Work Order ID 151365

Item Name: Replacement Skidtube (Fits LH or RH)

DRAWING NO. D2650	TITLE 206/407 SKIDTUBE ASSEMBLIES	REV. F	DART AEROSPACE LTD ENGINEERING ORDER		D.E.O. NO. D2650-F-1	SHEET NO. SHEET 1 OF 1	SCALE NTS
DRAWN <i>[Signature]</i>	CHECKED A.P.	MFG. APPR. <i>[Signature]</i>	APPROVED <i>[Signature]</i>		DE APPR. <i>[Signature]</i>		
DATE 12.10.12	DATE 12.10.22	DATE 12.10.22	DATE 12.10.22		DATE 12.10.22

CHANGE C'BORED WELDED CROSSBOLT SPACERS TO SWAGED SPACERS

DETAIL G

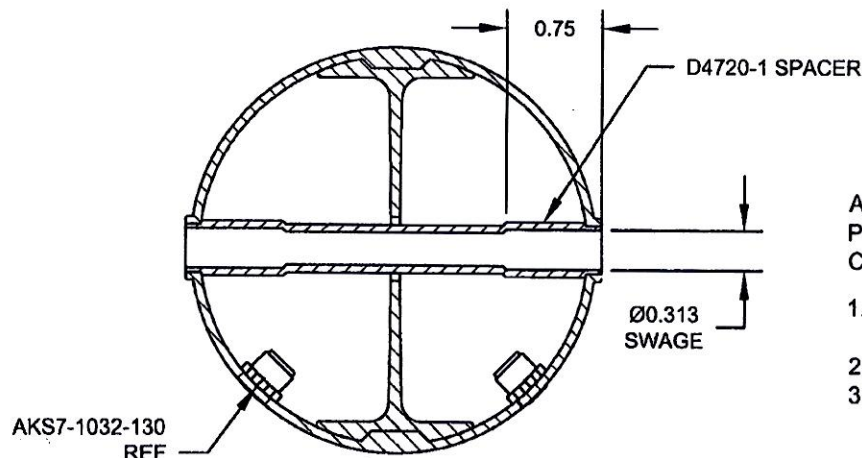
ADD DETAIL G BELOW, WHICH IS THE SAME SECTION VIEW AS DETAIL D OF DWG.
C'BORED HOLES ARE **NOW SWAGED** PER DETAIL G BELOW. FOR THE Ø0.375 HOLE THAT IS NOT C'BORED, WELD PER DETAIL D OF DWG (SEE AMENDED DETAIL B FOR REFERENCE).

FOR Ø0.375 HOLES ONLY

FOR HOLES THAT ARE CURRENTLY C'BORED ONLY

AFTER DRILLING AND BENDING ASSEMBLY
PERFORM THE FOLLOWING FOR Ø0.375 HOLES THAT ARE
CURRENTLY C'BORED:

1. INSERT D4720-1 SPACER, 16 PL (-1) OR 17 PL (-3)
OR 19 PL (-5) OR 23 PL (-7)
2. SWAGE TO Ø0.313 X 0.75 DP PER QSI 002
3. TRIM / GRIND FLUSH PER QSI 002
